FINAL ENVIRONMENTAL IMPACT STATEMENT ON

THE PROPOSED MONTANA POWER COMPANY CLYDE PARK-DILLON
161 KILOVOLT AND 69 KILOVOLT TRANSMISSION LINES

ENERGY PLANNING DIVISION
ALBERT C. TSAO, ADMINISTRATOR
DEPARTMENT OF NATURAL RESOURCES & CONSERVATION
GARY J. WICKS, DIRECTOR

APRIL 1976

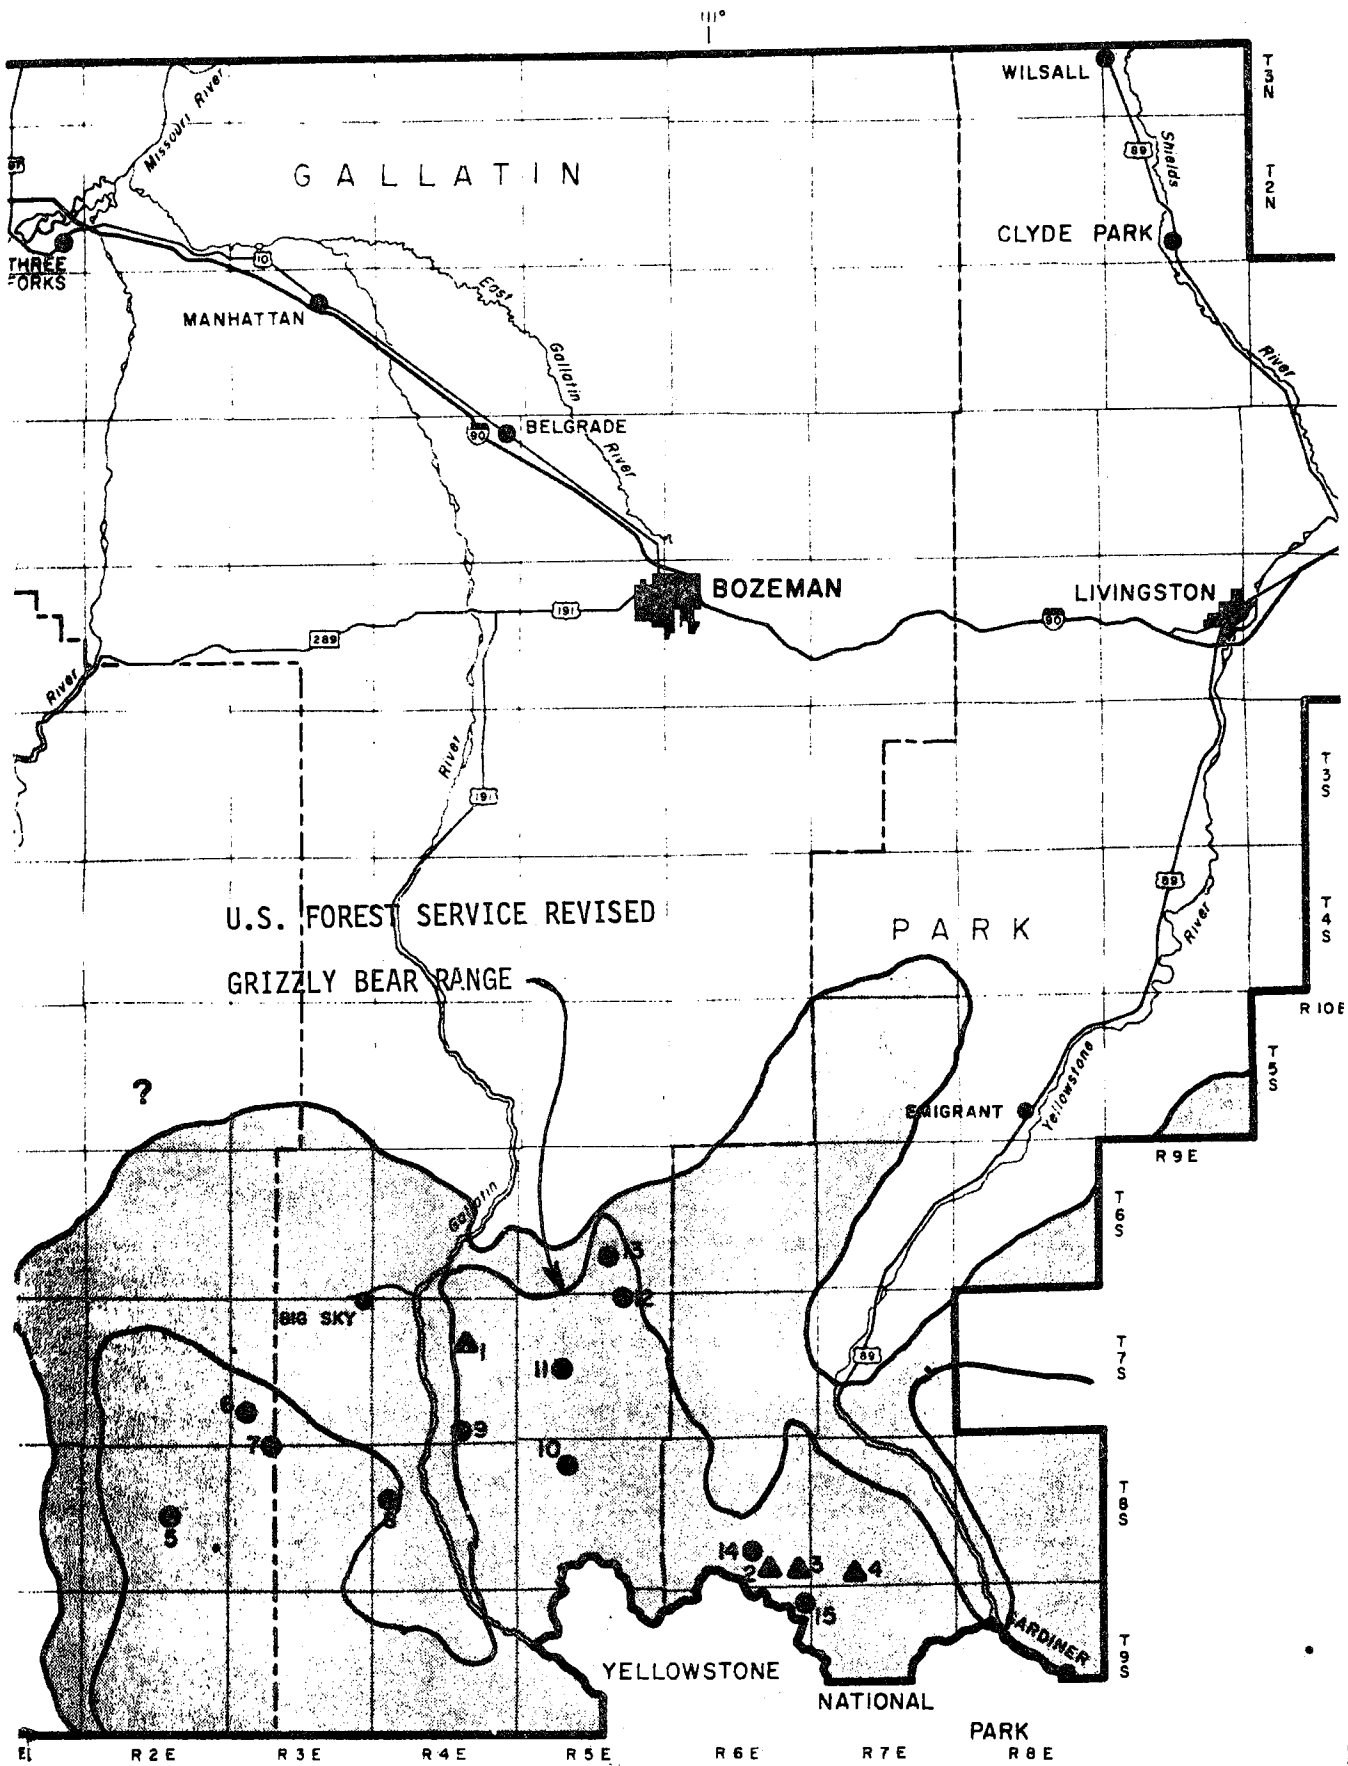
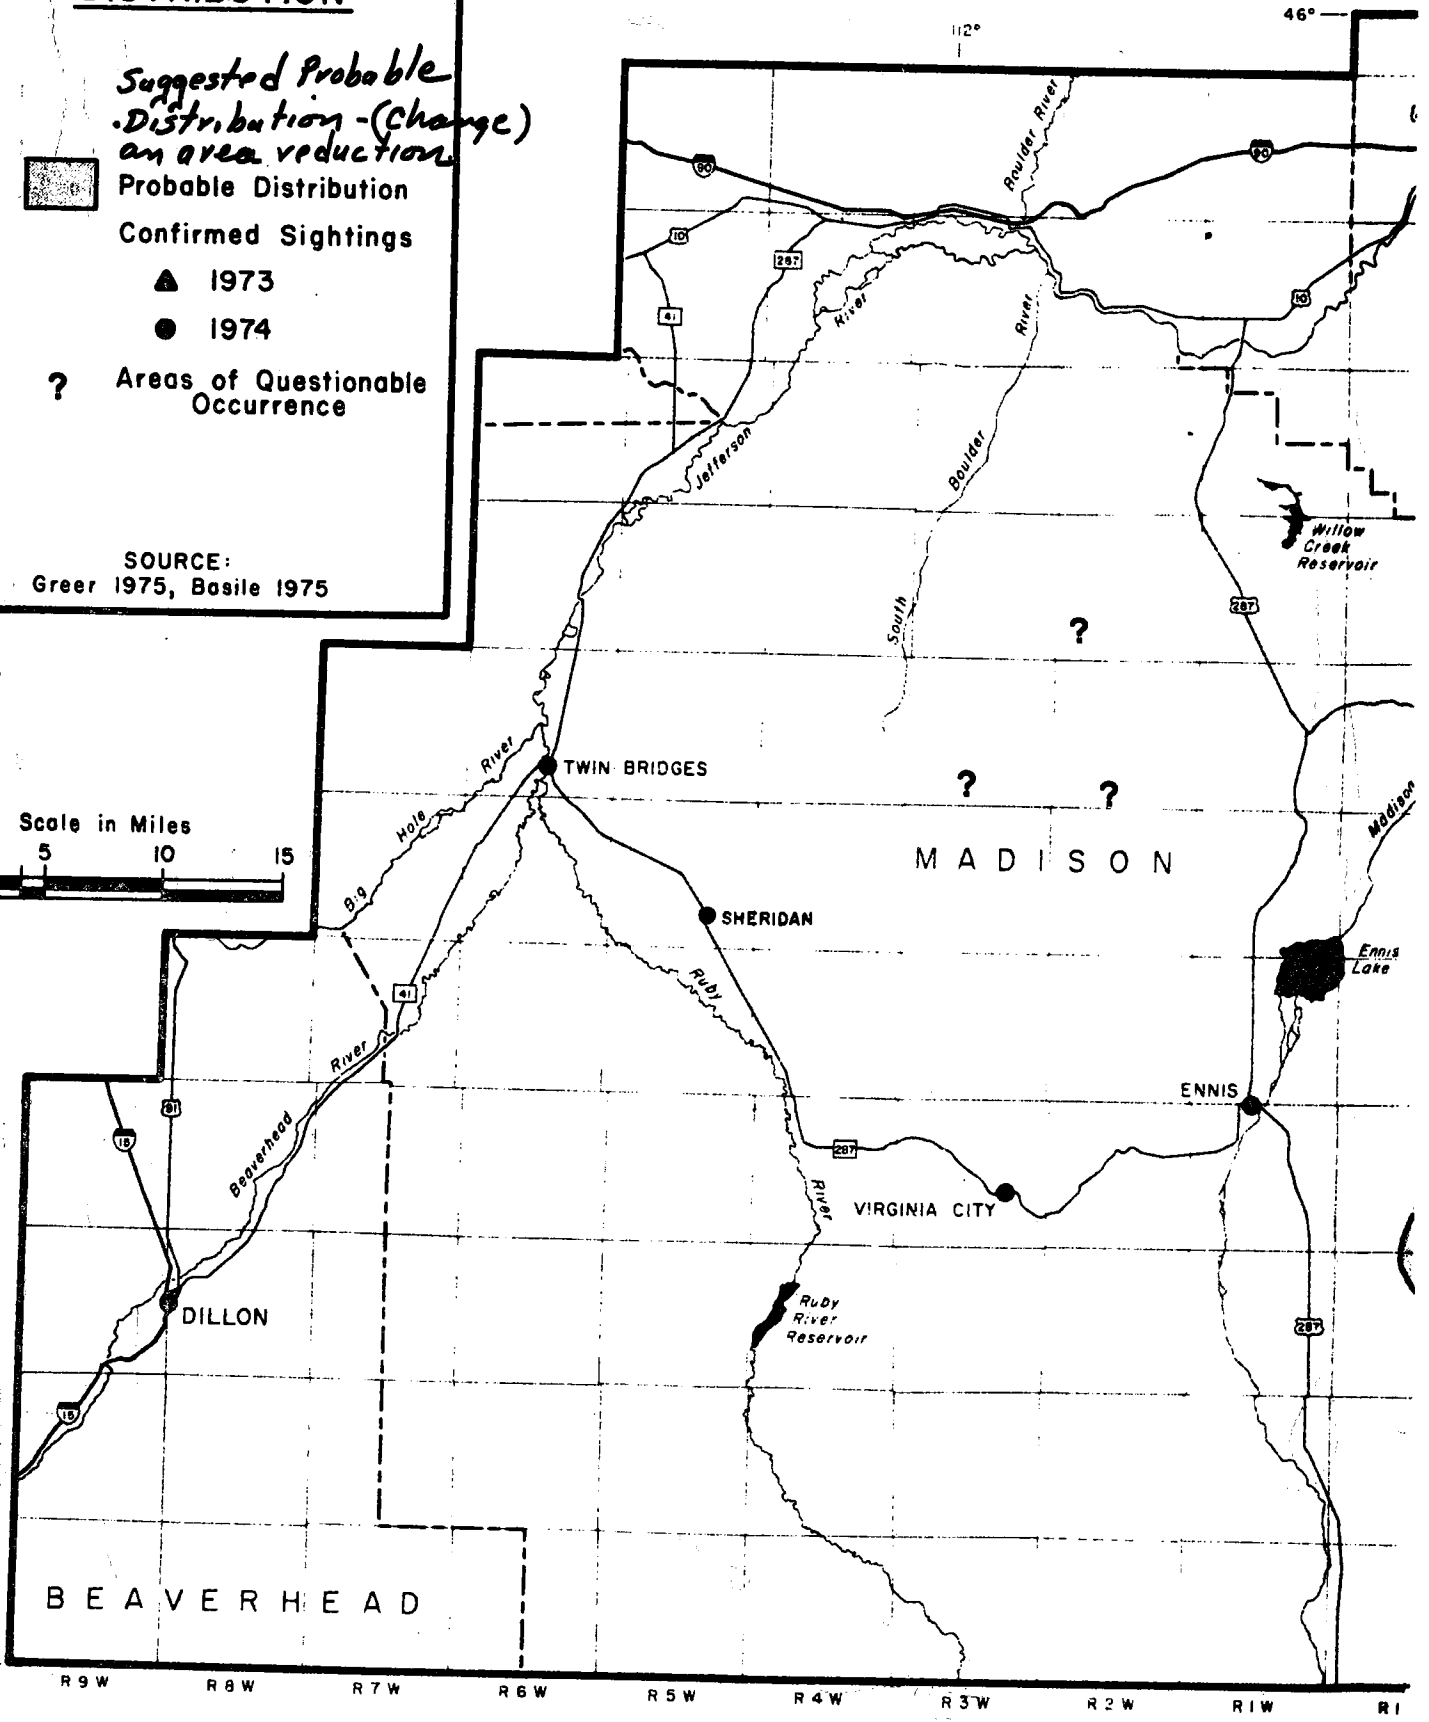
A comment was made by the USFS suggesting that references to grizzlies requiring a "wilderness-like area" be deleted, and that the area delineated on the grizzly habitat distribution map be reduced to a smaller size, to conform with a USFS inventory. (A map was also furnished.)

The map furnished by the USFS (Figure 1) shows ". . . the distribution boundary we [Forest Service] have inventoried . . ." being ". . . a result of recent study and deliberation." This map appears to be a connection of dots which includes as little area within the boundary as possible, while still including the sightings shown. It seems that the USFS considers the few confirmed sightings shown on the map as the extent of grizzly bear distribution in the area. This is not the case. First, sightings indicated on the map represent only confirmed sightings made during 1973 and 1974. These sightings

There seems to be confusion in the USFS comment regarding the definitions of "habitat" and "distribution." These are two different terms, and are discussed to some length on pages 211-212 of the Draft EIS. On page 212 is the statement: ". . . it should be realized that the boundaries of the general distribution of a species are not absolute." This applies to the boundary of "probable distribution" on the published "Grizzly Bear Distribution" map in the Draft EIS, as well as the suggested USFS changes. These lines are nothing more than lines of probability, as discussed on page 212 of the Draft EIS. The absolute or even probable distributional boundaries of the grizzly bear in this area are unknown--the USFS boundary represents one informed guess; the Department boundary, another.

The important consideration is the distribution of suitable habitat. Where suitable habitat exists, chances are high that resident grizzly populations will be found. The area labeled "probable distribution" on the Department's map is an approximate outline of habitat areas appearing to be suitable for grizzly bears, whether known to be occupied or not. It is highly probable that future observation and study will reveal grizzly sightings throughout this area. In any case, it is unrealistic to assume that distribution or habitat stops precisely where marginal chance sightings were made (Viz. sightings nos. 1, 8, 9, 12, and 13 in Figure 1), or that the bears did not move when the observation ceased.
